Historical Architectural Review Board COA Preliminary Review Sheet

HDC-2024-00035

Address: 245 N 11th Street

Proposal: Roof Replacement

Current Roof (Applicant)

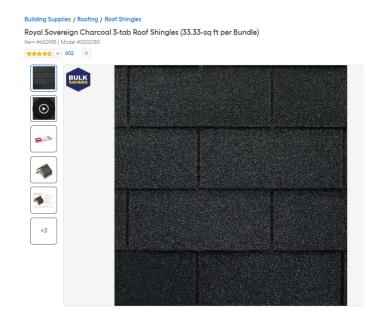
<u>Observations & Comments:</u> It appears that the existing roof is a non-historic 3-tab asphalt shingle roof and the proposed replacement material is an in kind replacement. Though, it is not clear if the proposed color matches the color of the existing roofing. The guidelines indicate that replacement materials should match the existing in color, which appears to be a medium to dark grey.

<u>Staff Recommendation:</u> It is recommended to approve, with conditions related to the color of the in-kind replacement material selected to better match the existing roofing.

Discussion: The applicant noted the shingle colors will match the existing and the previous owner did a lot of repairs; the front is slate with silver coat and the back is 3-tab with architectural shingles. Given the clarification of the current roofing material, GAF Slateline or similar is recommended for the front slope. Discussion was held about what should be considered in-kind given the number of roofing surfaces that exist on the roof. The applicant noted that it is an increased expense for the shingle cost as well as installation cost for the GAF Slateline shingles. The applicant noted the Slateline shingles install differently than architectural shingles and there is less to a bundle for Slateline. Given the existing conditions, it was noted that GAF Slateline or similar would be acceptable at the front and 3-Tab or Slateline will be acceptable at the back.

- Replacement material to resemble the original roofing as closely as possible (GAF Slateline Shingle or similar) will be utilized.
- At the back slopes, if the owner chooses, in-kind replacement of 3-Tab shingles can be utilized in lieu of Slateline.
- Color to match existing roofing materials (Charcoal or similar.)
